SECTION 00 91 13.02 – ADDENDA NUMBER 02

- A. Project Name: Reroofing and Related Work West Woods Upper Elementary, 50 Judson Lane, Farmington, Connecticut
- B. Owner: Town of Farmington, Connecticut
- C. Architect: Jacunski Humes Architects, LLC
- D. Architect Project Number: 2436
- E. Date of Addendum: April 4, 2025.

A. Overall Roof Area Test Cut (TC) Key Plan:

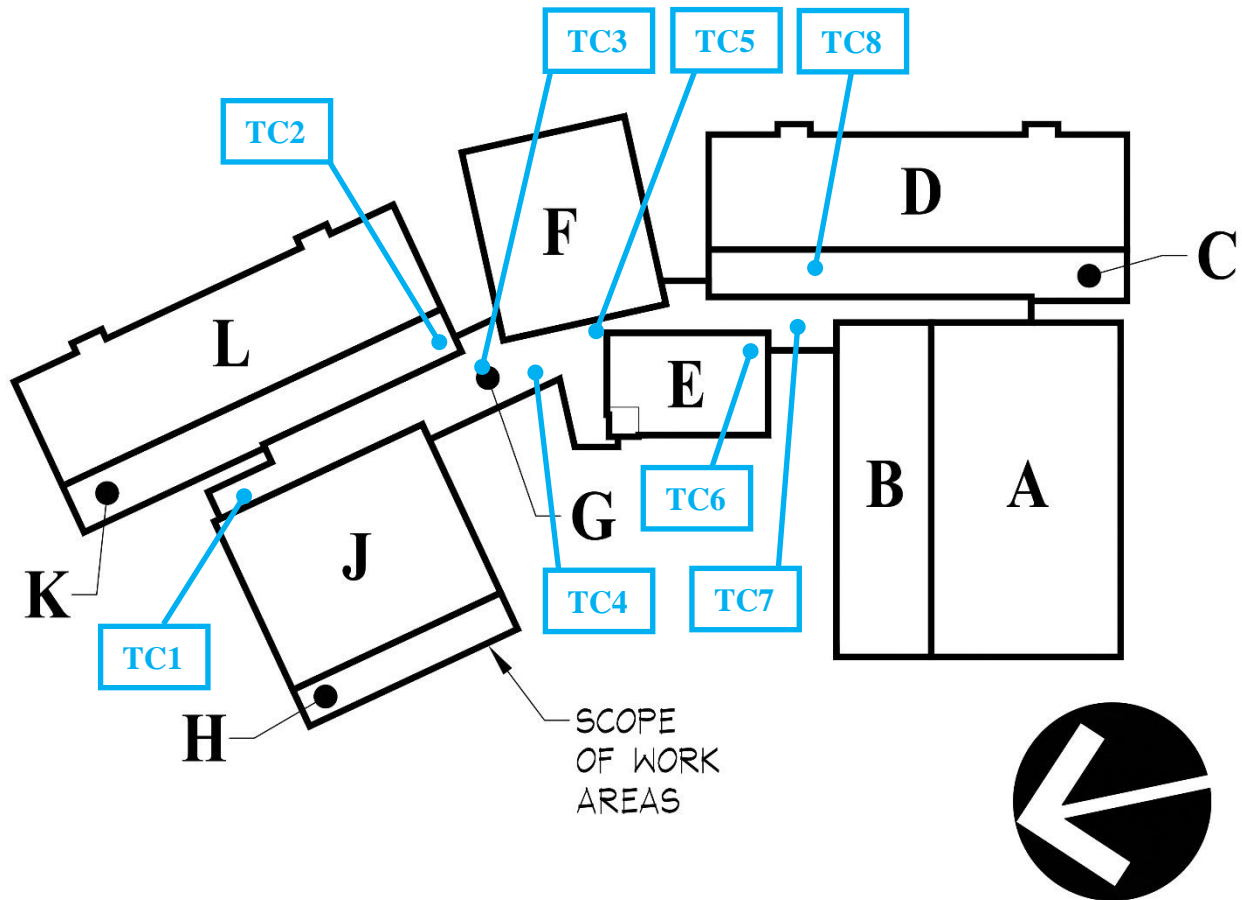
- A. Section 00 21 13, ‘Instructions to Bidders’, paragraph 5, Questions and Addenda’, sub-paragraph A:
 - 1. **REVISE** owner email address from “bids@fps.org” to “bids@fpsct.org”.
- B. **REPLACE** Section 00 31 25, ‘Existing Material Information’ with revised version dated “April 4, 2025”:
 - 1. Revision includes addition of identification of gravel surfacing layer and 4-ply for the built-up roofing.

- A. **TC1:** Observed assembly from top to bottom:
1. Gravel surfacing layer
 2. 4-ply built-up asphalt roofing
 3. 3.25-inch total thickness (2 layers) polyisocyanurate rigid insulation
 4. Metal roof decking
- B. **TC2:** Observed assembly from top to bottom:
1. Asphalt shingle roofing
 2. Ice and water shield membrane

3. Plywood roof decking
- C. **TC3:** Observed assembly from top to bottom:
1. Gravel surfacing layer
 2. 4-ply built-up asphalt roofing
 3. 5.50-inch total thickness (3 layers) polyisocyanurate rigid insulation

4. Wood roof decking
- D. **TC4:** Observed assembly from top to bottom:
1. Gravel surfacing layer
 2. 4-ply built-up asphalt roofing
 3. 1.75-inch total thickness (1 layer) polyisocyanurate rigid insulation

4. Wood roof decking
- E. **TC5:** Observed assembly from top to bottom:
1. Gravel surfacing layer
 2. 1.5-inch overall thickness of 4-ply built-up asphalt roofing and flashing

3. 9.50-inch total thickness polyisocyanurate rigid insulation
 4. Wood roof decking
- F. **TC6:** Observed assembly from top to bottom:
1. Gravel surfacing layer

2. 4-ply built-up asphalt roofing
 3. 3.50-inch total thickness (2 layer) polyisocyanurate rigid insulation
 4. Metal roof decking
- G. **TC7:** Observed assembly from top to bottom:

1. Gravel surfacing layer
 2. 4-ply built-up asphalt roofing
 3. 4.50-inch total thickness (2 layers) polyisocyanurate rigid insulation
 4. Wood roof decking

- H. **TC8:** Observed assembly from top to bottom:
1. Asphalt shingle roofing
 2. Felt underlayment
 3. Plywood roof decking
